APPLICATION NO.	FILING DATE	FIRST NAMED INVENTOR	ATTORNEY DOCKET NO.	CONFIRMATION NO.
10/710,846	08/06/2004	Eckhard Napp	EP0209445	4845
30008	7590	12/02/2005	EXAMINER	
GUDRUN E. HUCKETT DRAUDT LONSSTR. 53 WUPPERTAL, 42289 GERMANY			FERGUSON, MICHAEL P	
			ART UNIT	PAPER NUMBER
			3679

Office Action Summary	Application No. 10/710,846	Applicant(s) NAPP, ECKHARD	
	Examiner Michael P. Ferguson	Art Unit 3679

DETAILED ACTION

wherein the first profile and the second profile in the joined state define a cutout **A,B** (Figure 5 reprinted below with annotations) bridging the partition line and extending on both sides of the partition line;

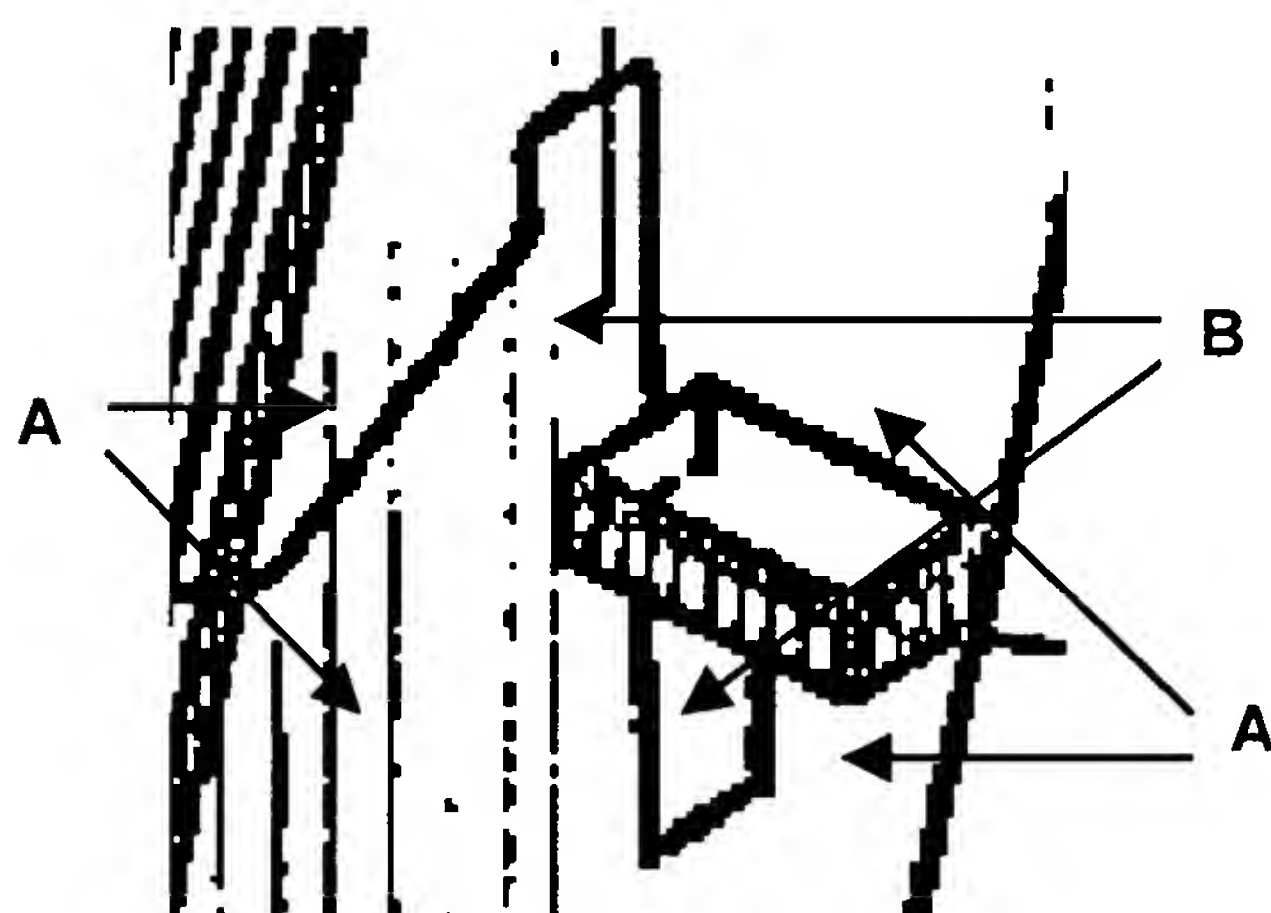
a separate locking bar **34** having a cross-sectional shape matching a cross-section of the cutout;

three components of the unit in a locking direction opposite to the direction of the predetermined degree of freedom immediately before reaching the connecting position (Figure 5).

As to claim 2, Swanson discloses a connecting device wherein the first and second profiles each have an undercut **A** and wherein the first and second profiles engage one another in the connecting position by mutually engaging the undercut (Figure 5).

As to claim 3, Swanson discloses a connecting device wherein the first and second profiles each have an undercut **B** and wherein the locking bar **34** engages the undercut of the first and second profiles (Figure 5).

As to claim 4, Swanson discloses a connecting device wherein the first and second profiles each have a first undercut **A** and a second undercut **B**, wherein the first and second profiles engage one another by mutually engaging the first undercut, and wherein the locking bar **34** engages the second undercut, respectively (Figure 5).

As to claim 5, Swanson discloses a connecting device wherein a longitudinal axis of the locking bar **34** extends perpendicularly to the direction of the predetermined degree of freedom (Figure 5).

As to claim 6, Swanson discloses a connecting device wherein a longitudinal axis of the locking bar extends at a slant (angle) to the direction of the predetermined degree of freedom (Figure 5).

As to claim 7, Swanson discloses a connecting device wherein the first and second rods **55** are joined at an acute angle, an obtuse angle or a right angle relative to one another (Figure 5).

As to claim 8, Swanson discloses a connecting device wherein four (not shown) of the first and second rods **34** are joined to form a frame (Figure 5).

As to claim 9, Swanson discloses a connecting device wherein the locking bar **34** is removable from the cutout **B** (Figure 5).

As to claim 10, Swanson discloses a connecting device wherein the locking bar **34** is non-releasable (locked in position due to friction-fit) once inserted into the cutout **B** (Figure 5).

As to claim 11, Swanson discloses a connecting device wherein the locking bar **34** has a cross-section selected from the group consisting of a rectangular shape, a circular shape, a diamond shape, a figure eight shape, a dovetail shape, an elliptical shape, and a cross shape (Figure 5).

As to claim 14, Swanson discloses a connecting device wherein the first and second profiles in the joined state have rotation symmetry (Figure 5).
